To: Rickelle Williams, City Manager
From: Talal Abi-Karam, Assistant Utilities Director
Date: November 4, 2025
Re: Change Order No. 1 for Project #P11589

Job Description: Project P11589, Project Fiveash Water Treatment Plant – Sluice Gates Replacements
Contractor: RF Environmental Services, Inc.
Amount: Total amount of Change Order # 1 - \$2,439.65
Funding: 10-495-7999-536-60-6599-P11589

Project File: P11589 Fiveash WTP Repairs – Sluice Gate Replacement CHANGE ORDER SUMMARY SHEET

Project: Fiveash WTP - Sluice Gate Replacement Project No. P11589
Reference: Gate #11 Replacement Plan

Drawing Two: Isolation Plan for Sluice Gate Replacements

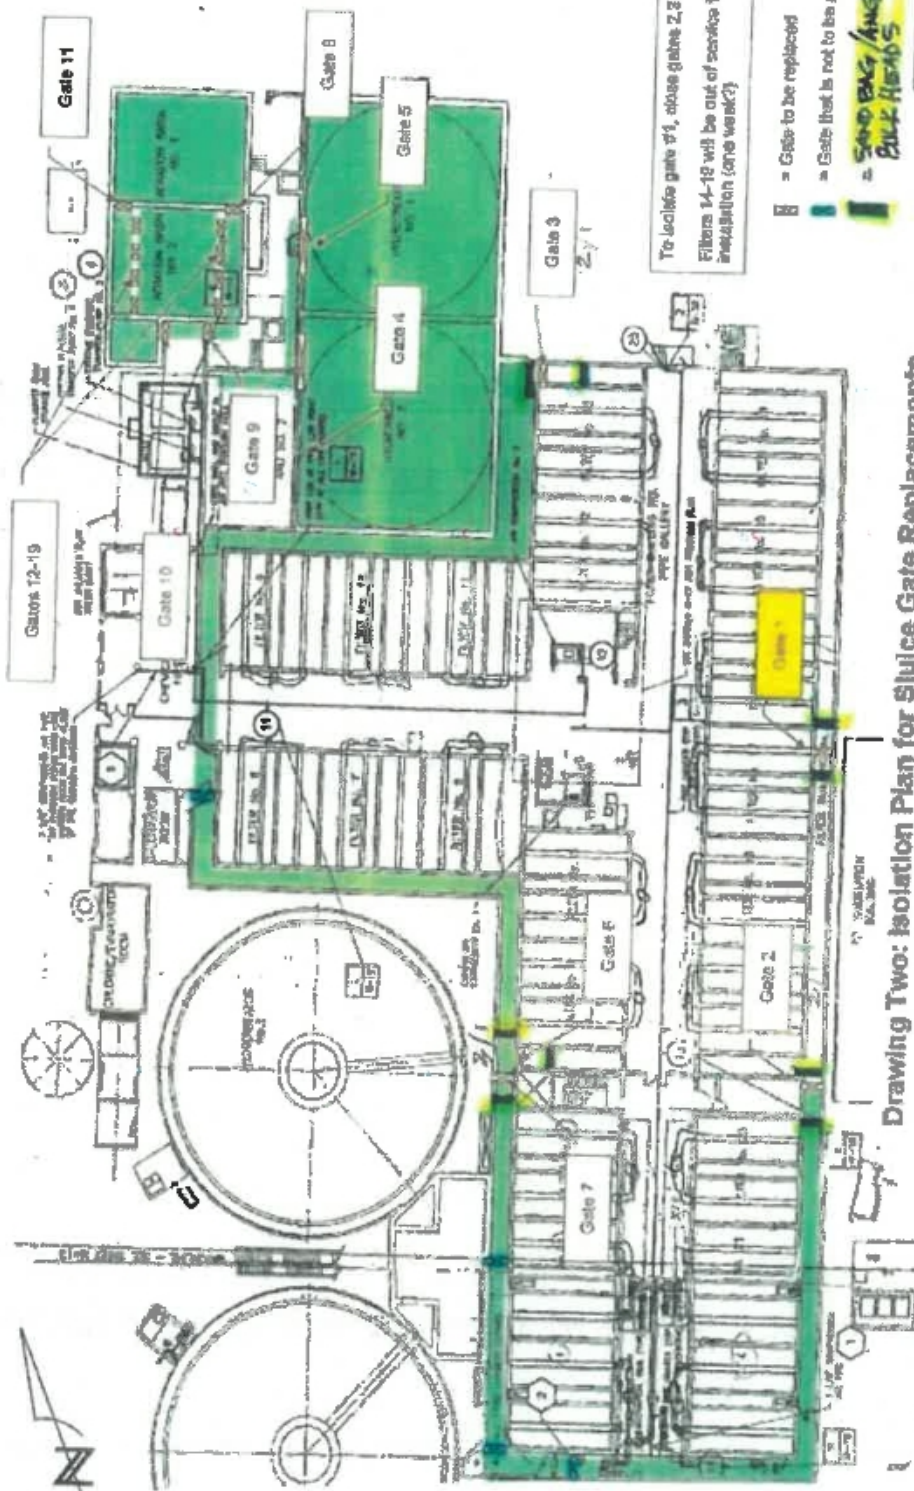
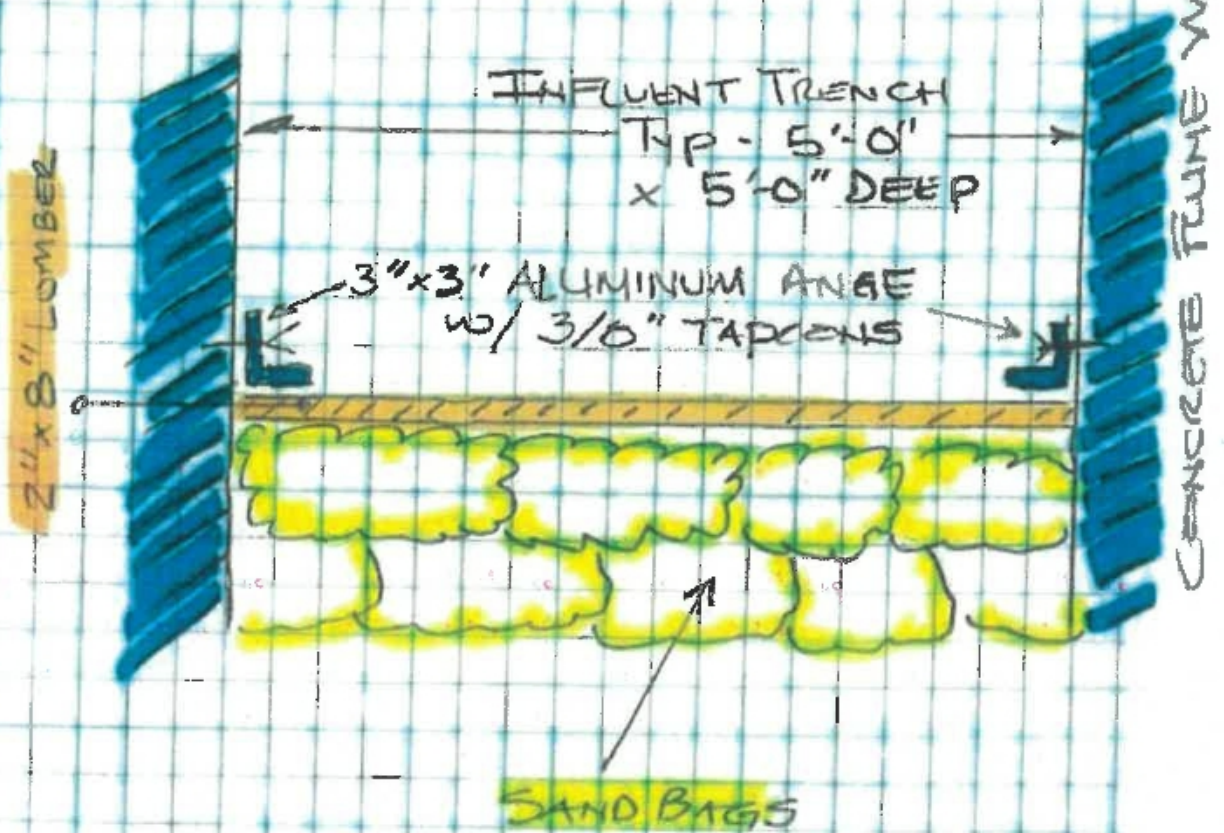
- Item No. CO1-3 Description: Construction of Temporary Bulkheads
The Contractor installed sandbag berms inside the channels before and after gates to be replaced to block water flow so the Contractor could remove water in the channel and install new gates in five locations. The Contractor's methods improved upon the gate isolation plan provided in the bid documents.
ADD \$25,404.12

As a follow-up to numerous site meetings RF Environmental Services, Inc. (RFES) was required to install temporary bulkheads in the Filter Influent Flumes in order to minimize the flow disruptions to as few filters as possible. RFES had to install these bulkheads to complete our contract work for Gate #'s 1, 2, 3, 6 & 7, see attached detail of the typical bulkhead which had to be installed on each side of the gate being replaced, the attached site plan shows the location of these bulkheads. As shown on the "Typical Bulkhead Detail" drawing, each bulkhead included: 3" x 3" aluminum angles bolted to the flume walls, 2" x 8" wood bulkheads and (2) rows of sandbags. Please see the attached detailed cost proposal for the installation and removal of these bulkheads, required as a result of the City not being able to shut-off flow in the filter influent flume so RFES can complete our work. This "Lump Sum" proposal is in the amount of \$25,404.12, per the attached detail cost break-down.
